Re: Interim Landfill Gas Extraction System Design, FF/NN Landfill, Ripon, Wisconsin

FF/NN LANDFILL RIPON, WISCONSIN	DATE: 8/5/05
	DESIGNED: GLD
INTERIM GAS SYSTEM LAYOUT	CHECKED: RRS
	APPROVED: GLD
	DRAWN: HJW
	PROJ.: 1011.002

Figure 1

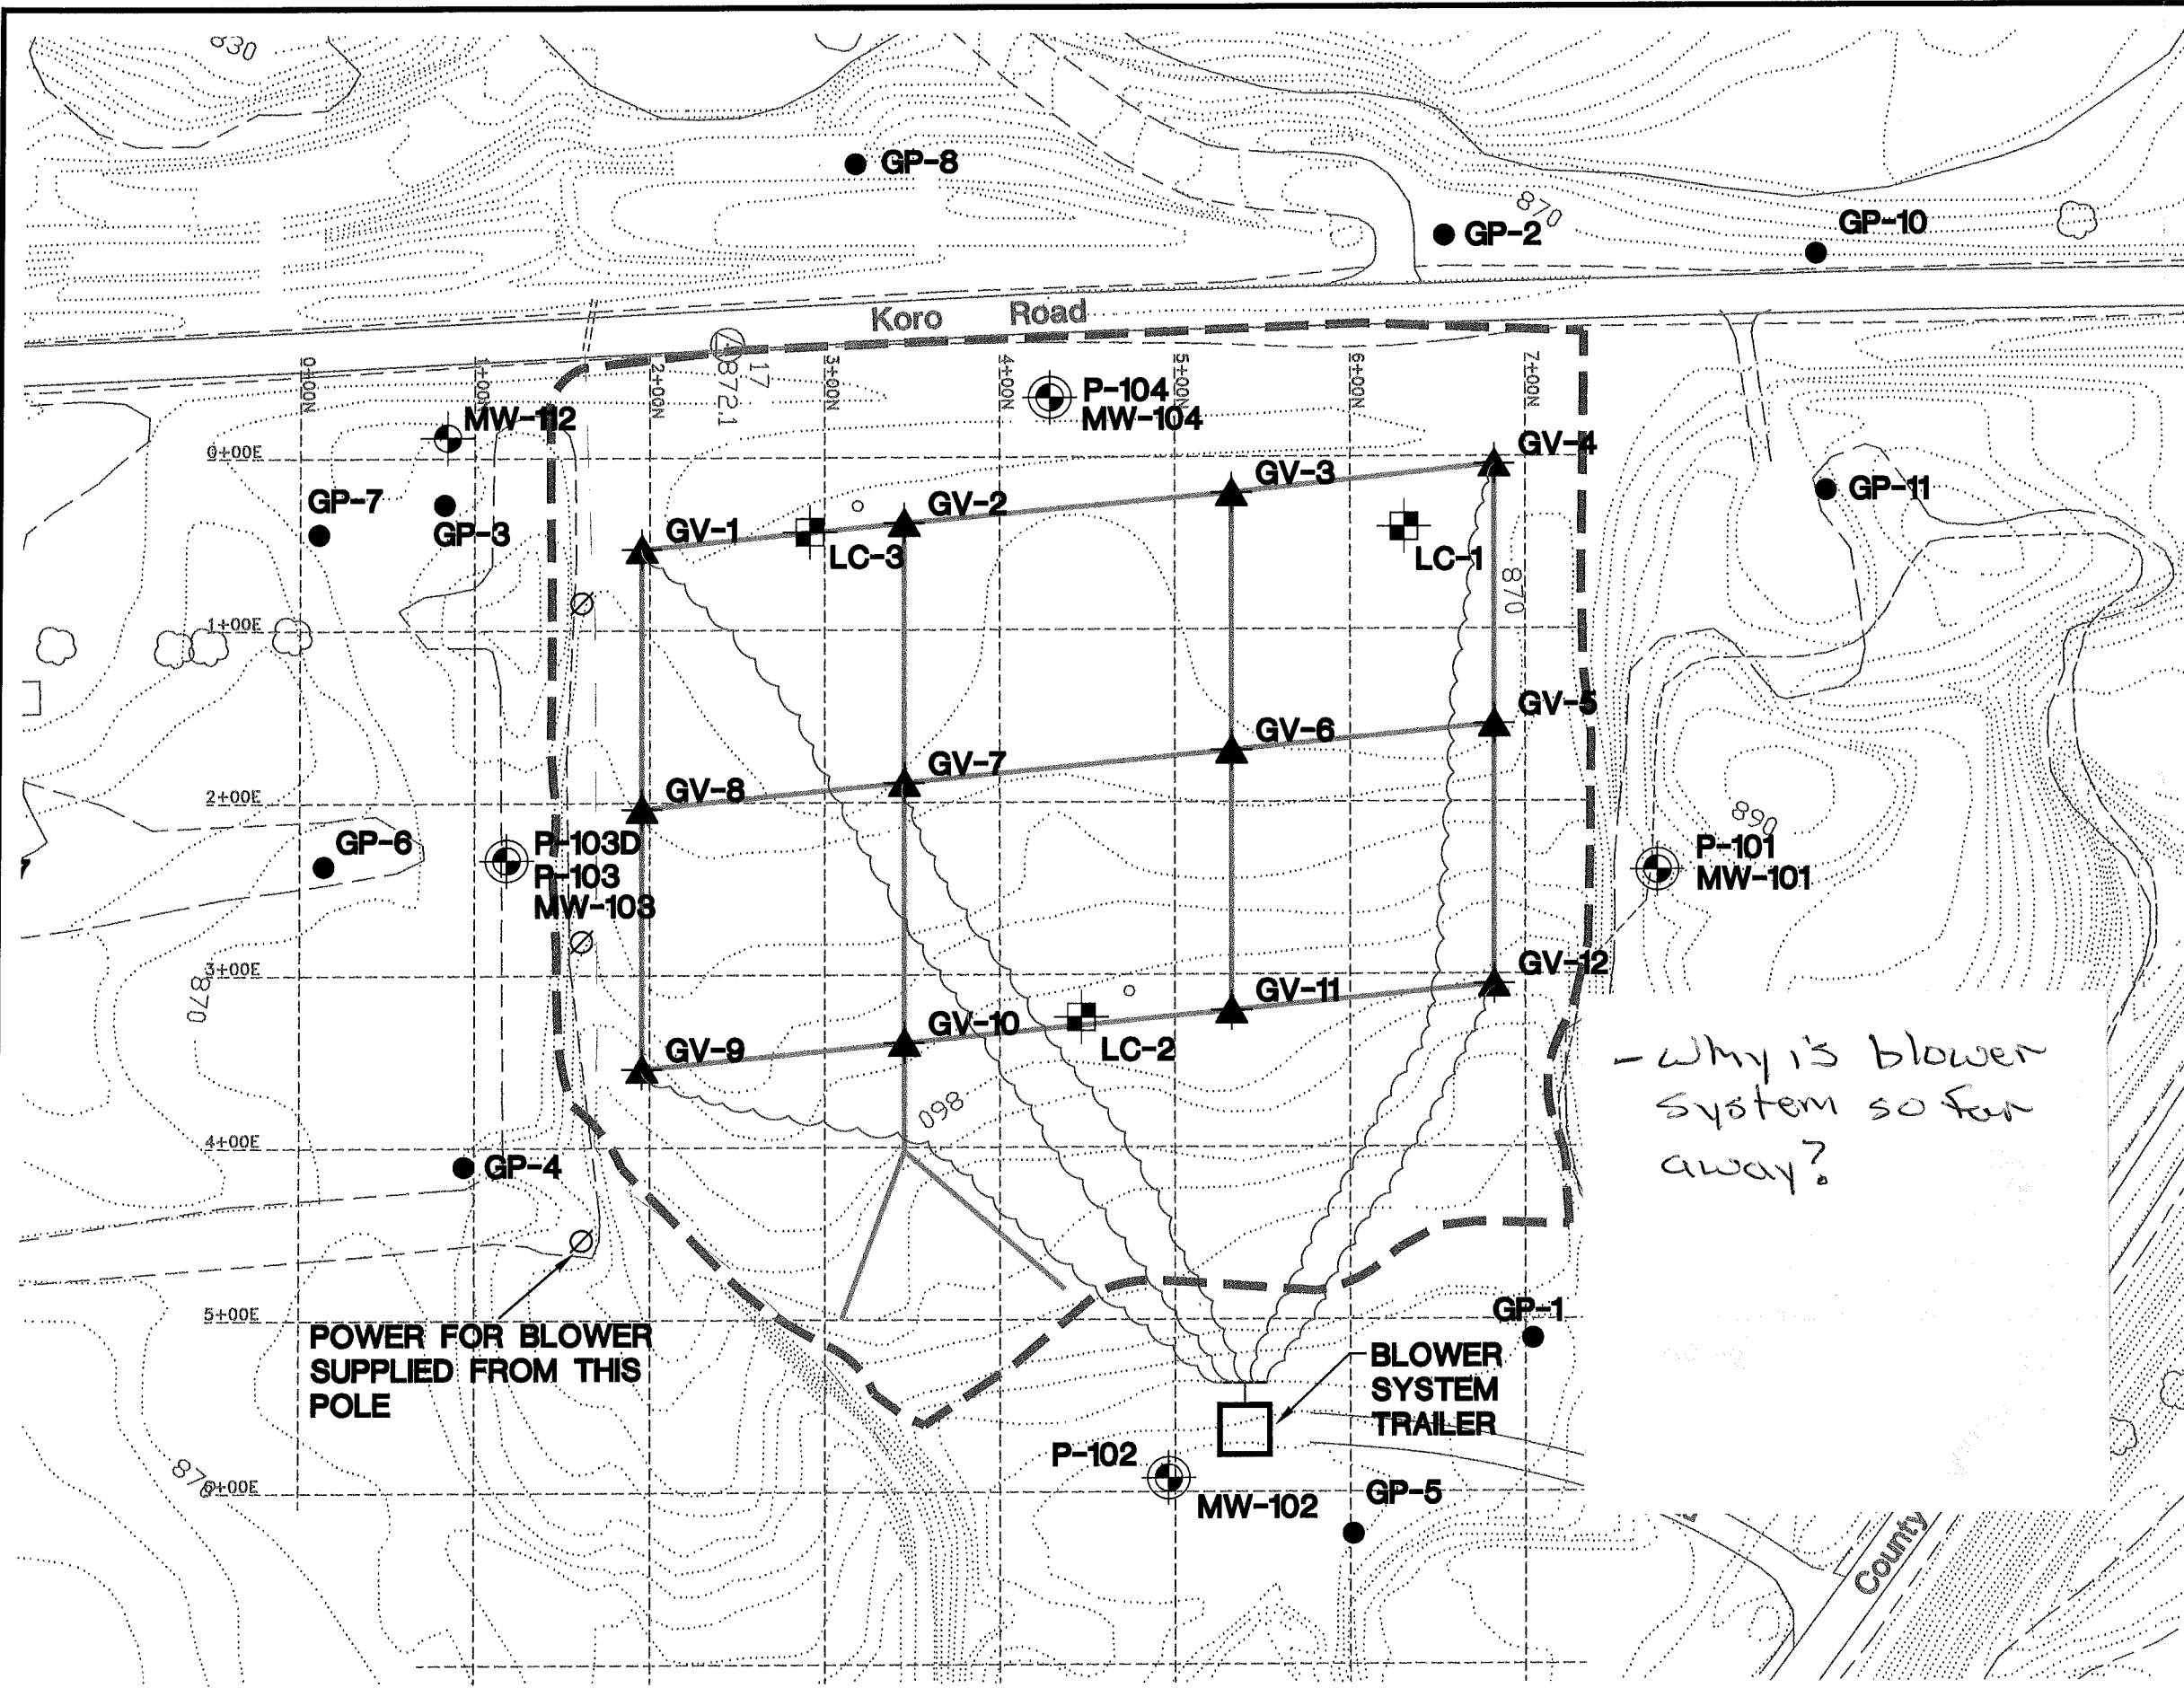
- Why is blower system so far away?
